Access Compliance Report

Public Rights-of-Way

(Curb Ramps)

Intersection ID: 27977	Main Street: EDINDALE_DR	Cross Street: HAWICK_VALLEY_LN	Location: SE
ADA ID: A769230F2417	Ramp Type: BlendTrans2	Initial Pass/Fail: Pass	Overall Compliance: No
Severity Score: 15.25			
Codes/Mitigation Info/Possible Solution		Field Measurements/Component Compliance

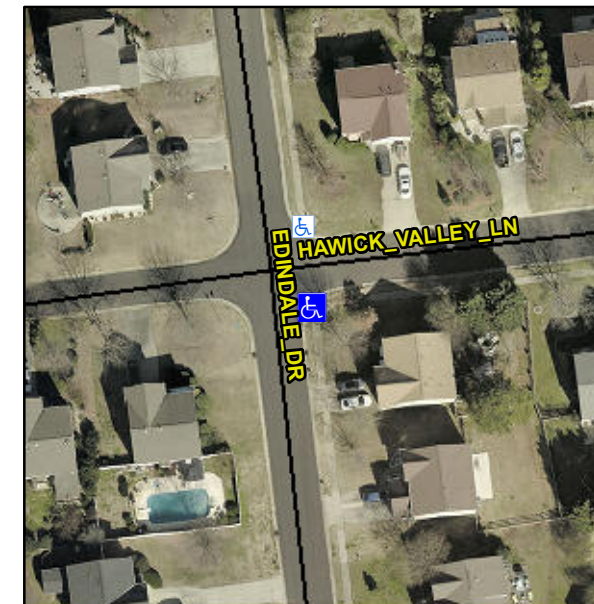
Not Found, R304.5.3, R305, R304.5.4

Compliance	Description	Data	Compliance	Description	Data
N/A	Ramp Length (in)	93.0	Yes	BlendTrans Slope (%)	4.2
Yes	Ramp Width (in)	86.0	No	BlendTrans XSlope (%)	3.1
N/A	Flare Type LT	None	N/A	Flare Type RT	None
N/A	Flare Slope LT (%)	N/A	N/A	Flare Slope RT (%)	N/A
N/A	Flare Traversable LT?	N/A	N/A	Flare Traversable RT?	N/A
N/A	Landing Length (in)	N/A	No	DWS Provided?	No
N/A	Landing Width (in)	N/A	N/A	DWS Contrast?	No
N/A	Landing Slope (%)	N/A	N/A	DWS Length (in)	N/A
N/A	Landing X Slope (%)	N/A	N/A	DWS Full Width?	No
N/A	Landing Curb? (Y/N)	No	N/A	DWS Offset (in)	N/A
N/A	Shared Landing?	No			
Yes	Gutter Ponding?	No	No	Gutter Slope (%)	6.5
Yes	Gutter Lip Ht (in)	0.0	No	Gutter X Slope (%)	2.2
N/A	Painted X Walk1?	No	N/A	Painted X Walk2?	No
	X Walk 1 Direction	To N		X Walk 2 Direction	To W
	X Walk 1 Width (in)	N/A		X Walk 2 Width (in)	N/A
	X Walk 1 Slope (%)	4.0		X Walk 2 Slope (%)	0.3
	X Walk 1 X Slope (%)	0.6		X Walk 2 X Slope (%)	5.0

N/A	Ramp inside XWalk1?	N/A	N/A	Ramp inside XWalk2?	N/A
	Road Slope (%)	2.9		Clear Space?	Yes
	Road X Slope (%)	1.5	N/A	Clear Space to XWalk (in)	N/A
Yes	Any Obstructions?	No	Yes	Storm Grate/Utility Hazard?	No
	Obstruction Type			Storm Grate/Utility Type	
		N/A			N/A
			Yes	Surface Condition? (G/P)	Good
			No	Curb Slope (%)	15.0

Remove & Replace Curb Ramp With Two New Directional Ramps or Equivalent. Remove & Replace Gutter.
